Private Fuel Storage, L.L.C.

February 15, 2000

EIS COMMITMENT RESOLUTION LETTER #5
DOCKET NO. 72-22 / TAC NO. L22462
PRIVATE FUEL STORAGE FACILITY
PRIVATE FUEL STORAGE L.L.C.

0599601-EY-3

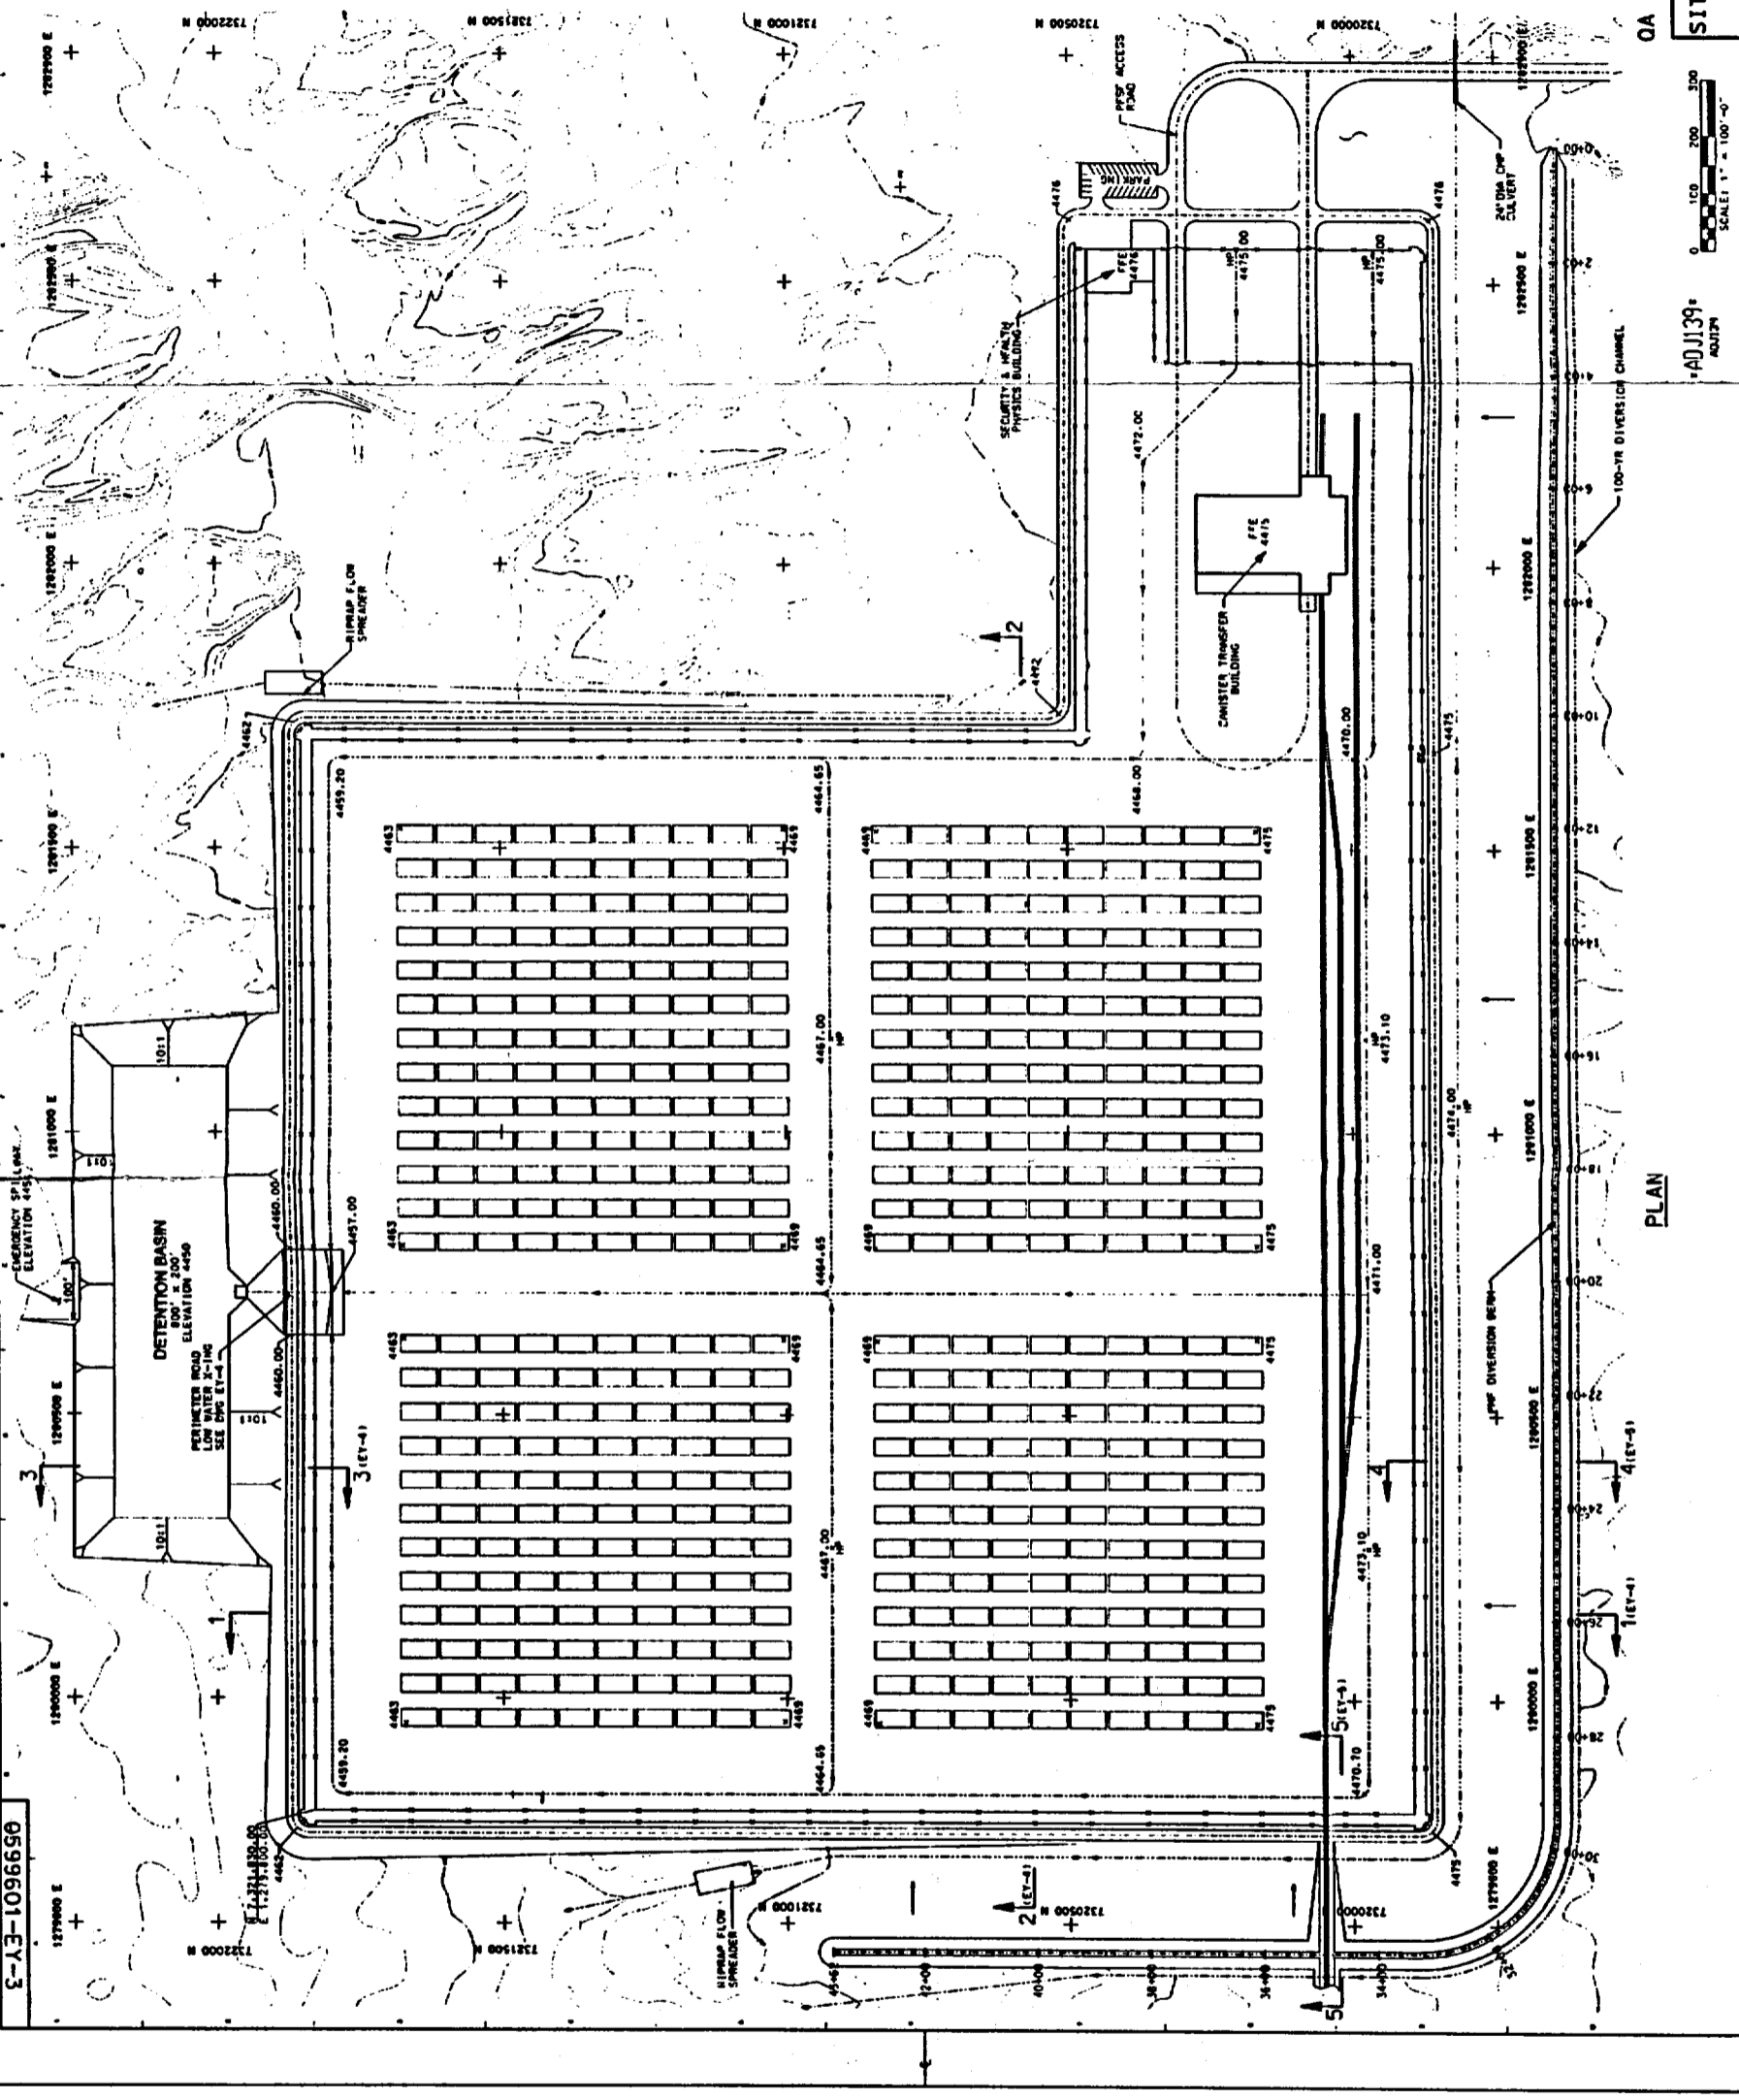
5. PFS needs to provide additional details on the construction of the Detention Basin. Include a discussion of what provisions will be taken to avoid wind and water erosion

of side slopes and provide any drawings that PFS has that shows the design of the basin.

RESPONSE - The detention basin is shown on drawings 0599601-EY-3 and 0500601-EY-4 (see attached copy). The 800' x 200' detention basin located immediately north of the storage area is designed to contain the 100-yr flood. The basin is designed with a concrete inlet from the storage site that precludes erosion from site drainage. The basin is constructed of compacted soil with 10 to 1 side slopes. Side slopes this gradual will reduce the velocity of rainwater flowing into the basin and minimize wind pressure thereby reducing the potential for wind or water erosion. In addition, the basin is located within the 300 wide wildfire barrier that will be planted with crested wheat grass. The presence of the crested wheat grass on the side slopes and bottom of the basin will stabilize the soil and help prevent erosion due to wind or water.

The detention basin is not expected to have standing water except possibly following a severe rainstorm. Water drainage from the storage site from a typical rainstorm is estimated to soak into the ground before it reaches the detention basin. The detention basin was sized for a 100-year flood event in which the depth of water in the basin was calculated to be 4.77 ft. (S&W Calculation No. 0599601-SY-2, Revision 0). In the unlikely event of a 100-yr flood, the time for the water that has collected in the basin to be removed via evaporation and ground percolation is approximately 140 days assuming an evaporation rate of 0.32 in/day (Houghton, Handbook of Applied Meteorology, 1985) and percolation rate of 0.09 in/day (Lambe & Whitman, Soil Mechanics, 1969). If this unlikely event occurred, temporary pumps would be used to drain the detention basin and eliminate long term standing water.

Figure 4.1-1
AGGREGATE SOURCES
 PRIVATE FUEL STORAGE FACILITY
 ENVIRONMENTAL REPORT

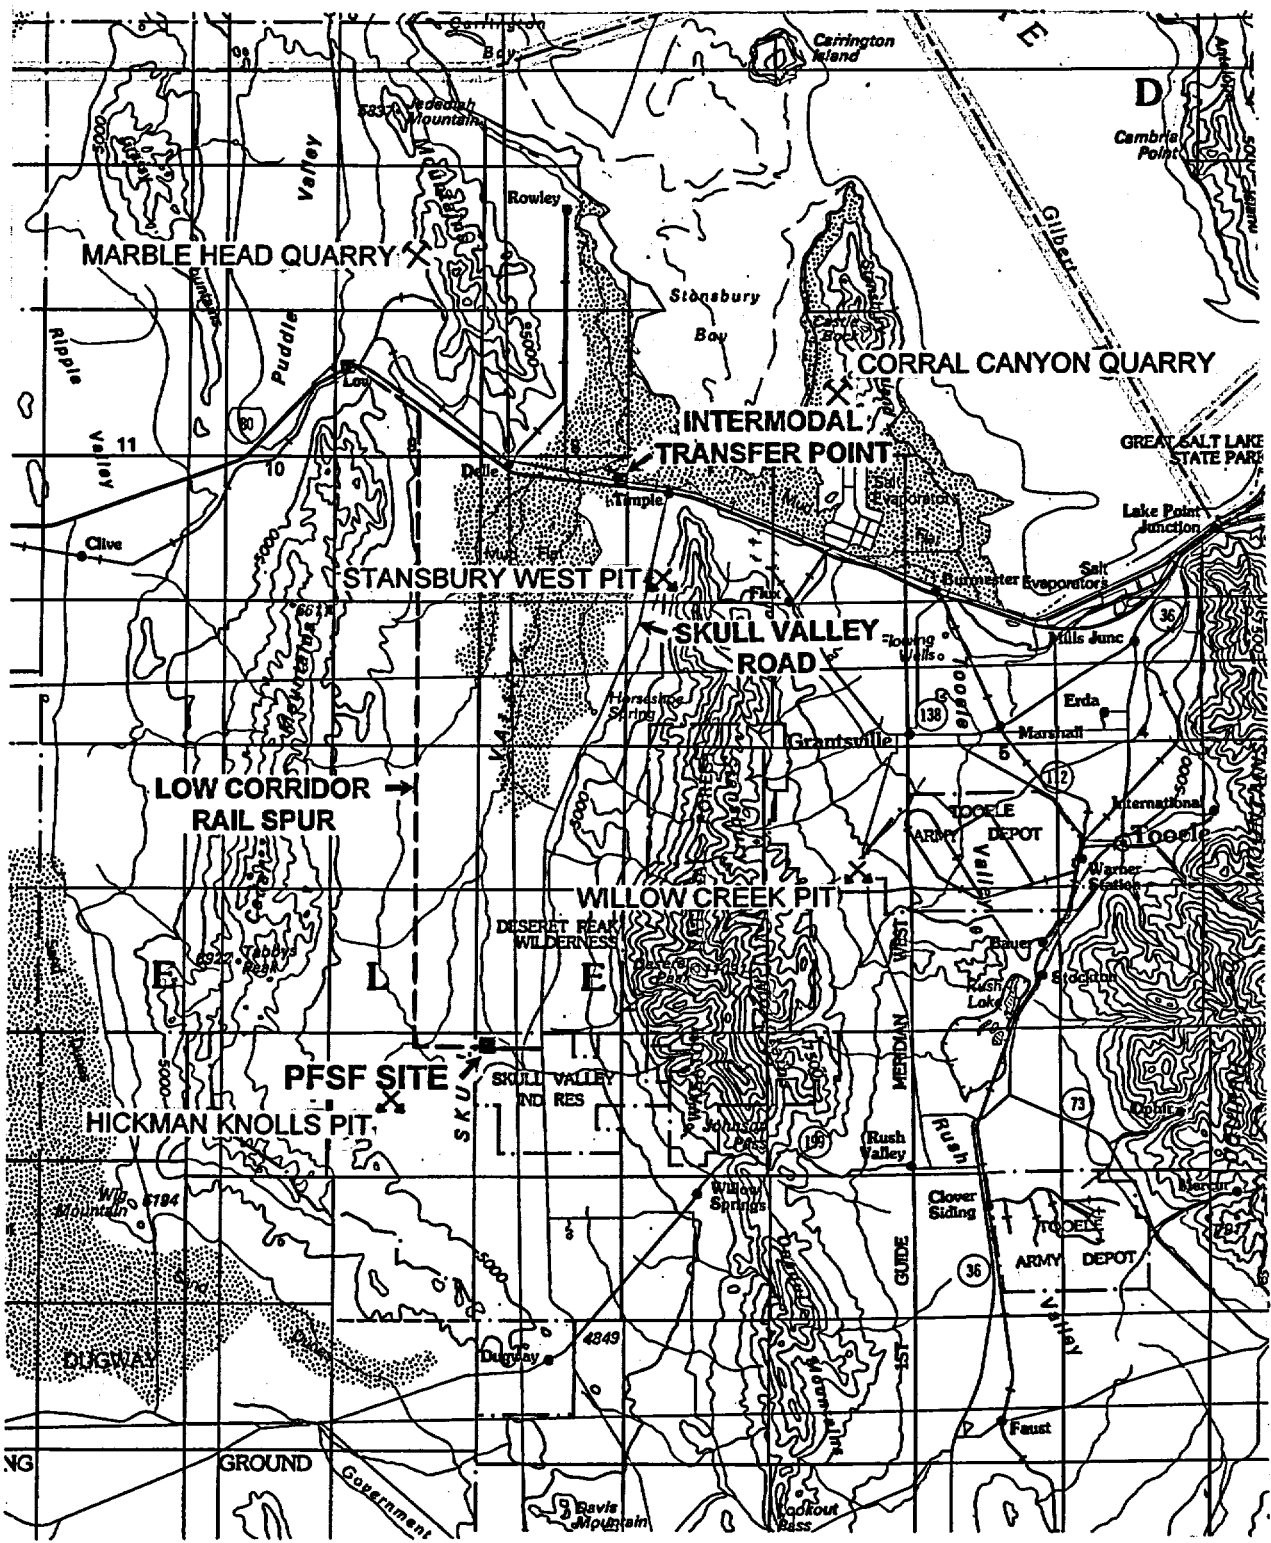
8. PFS should provide a map that shows the location of the aggregate sites in Skull Valley presented in ER Table 4.1-7. Additional information should be provided as to the operational status of each site and the permitting requirements/status of each site.

RESPONSE - A map showing the location of the nearby privately owned aggregate sites as listed in ER Table 4.1-7 is attached and will be incorporated into the next ER revision. For sand and gravel material, currently only the Willow Creek pit is in operation. However, the Stansbury West pit and Hickman Knolls pit can be reopened to provide necessary materials. For the railroad line ballast, only the Corral Canyon Quarry is in operation but the Marble Head Quarry can be reopened to provide ballast materials.
